Access Compliance Report

Public Rights-of-Way

(Curb Ramps)

Intersection ID: 14754	Main Street: SOUTH_BV	Cross Street: IVERSON_WY	Location: SW
ADA ID: FCC13B243CAB	Ramp Type: Perp	Initial Pass/Fail: Fail	Overall Compliance: No
Severity Score: 22.5			
Codes/Mitigation Info/Possible Solution		Field Measurements/Component Compliance

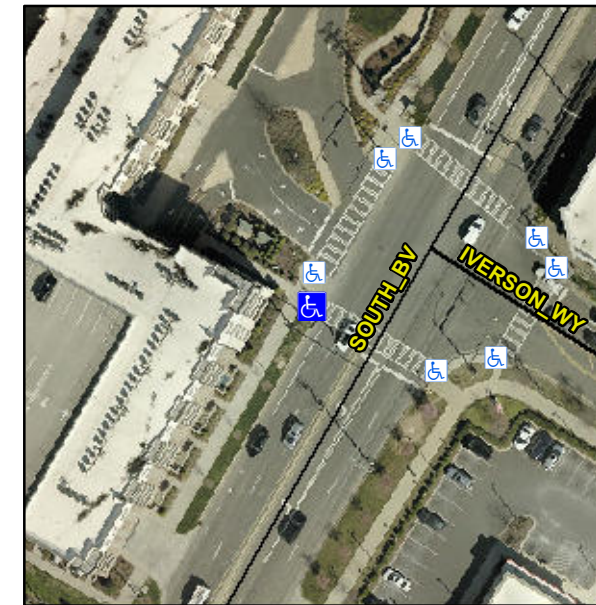
R304.5.1, R304.2.2, R304.5.3

Compliance	Description	Data	Compliance	Description	Data
N/A	Ramp Length (in)	72.0	No	Ramp Slope (%)	8.8
No	Ramp Width (in)	47.0	No	Ramp XSlope (%)	2.8
N/A	Flare Type LT	N/A	N/A	Flare Type RT	N/A
N/A	Flare Slope LT (%)	N/A	N/A	Flare Slope RT (%)	N/A
N/A	Flare Traversable LT?	N/A	N/A	Flare Traversable RT?	N/A
N/A	Landing Length (in)	N/A	N/A	DWS Provided?	N/A
N/A	Landing Width (in)	N/A	N/A	DWS Contrast?	N/A
N/A	Landing Slope (%)	N/A	N/A	DWS Length (in)	N/A
N/A	Landing X Slope (%)	N/A	N/A	DWS Full Width?	N/A
N/A	Landing Curb? (Y/N)	N/A	N/A	DWS Offset (in)	N/A
N/A	Shared Landing?	N/A			
N/A	Gutter Ponding?	N/A	N/A	Gutter Slope (%)	N/A
N/A	Gutter Lip Ht (in)	N/A	N/A	Gutter X Slope (%)	N/A
N/A	Painted X Walk1?	Yes	N/A	Painted X Walk2?	N/A
	X Walk 1 Direction	To SE		X Walk 2 Direction	N/A
N/A	X Walk 1 Width (in)	112.0	N/A	X Walk 2 Width (in)	N/A
	X Walk 1 Slope (%)	0.8		X Walk 2 Slope (%)	N/A
	X Walk 1 X Slope (%)	1.3		X Walk 2 X Slope (%)	N/A

Remove & Replace Entire Ramp.
